CRIME IMPACT STATEMENT

185 MANCHESTER ROAD, ROCHDALE

CARE SCHEME (COMPRISING OF 21 no. DEMENTIA CARE BEDROOMS, 48 no. NURSING BEDROOMS & 5 no. RESPITE BEDROOMS), WITH ASSOCIATED PARKING & LANDSCAPING

REFERENCE: 2023/0378/CIS/03

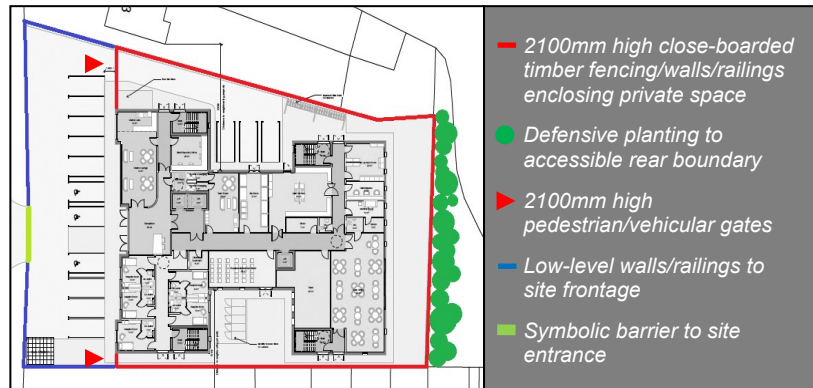
- 3.2.1 The proposed development will provide additional activity, surveillance and overlooking to the area at all times of the day and night.
- 3.2.2 The landscaped areas to the sides/rear of the building will be capable of being securely enclosed, preventing unauthorised access to where criminals could attack the building/exploit opportunities.

- 3.2.3 The proposed building will be staffed on a 24 hour basis and will have a clearly identifiable main entrance, which is capable of being robustly managed to control access. People arriving or leaving via the main entrance should be easily viewed by reception staff.

- 3.2.4 The proposed dementia and nursing bedroom will be provided above street level, meaning that residents' possessions cannot be easily observed and unauthorised entry is more effectively prevented. This also reduces the potential impacts of excessive noise, nuisance and anti-social behaviour (particularly at night).
